Access Compliance Report Public Rights-of-Way (RR Crossings)

Intersection ID: 10035790	Main Street: REMOUNT_RD	Location: N/A
ADA ID: BC5CA10404B1	Overall Compliance: No	Severity Score: 0.0
Codes/Mitigation Info/Possible Solution		Field Measurements/Component Compliance

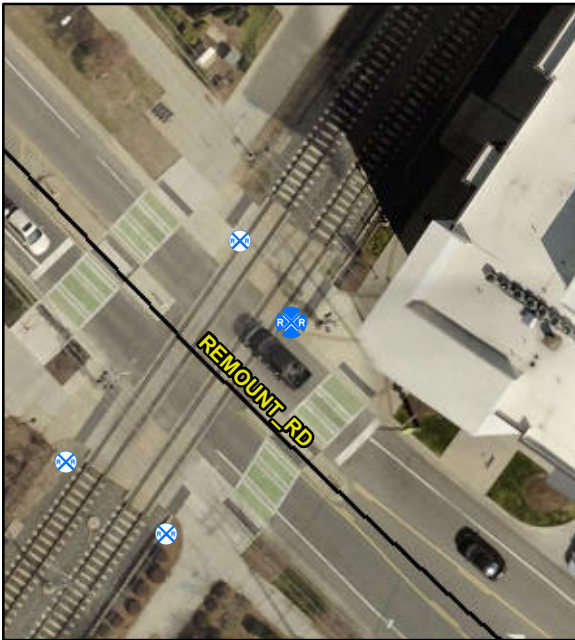
Remove & Replace Detectable Warning System. Provide Pedestrian Gate. Remove & Replace Walking Surface Adjacent to Rail.

R302.7.4, R305.2.5

Compliance	Description	Data
Yes	DWS Provided?	Yes
Yes	DWS Contrast?	Yes
Yes	DWS Width (in)	Yes
Yes	DWS Length (in)	36.0
No	DWS Offset (in)	28.5
No	Pedestrian Gate?	No
N/A	DWS Outside Gate?	N/A
N/A	Rail Type?	LightRail
No	Flangeway Gap (in)	3.0
Yes	Sidewalk Width (in)	123.0
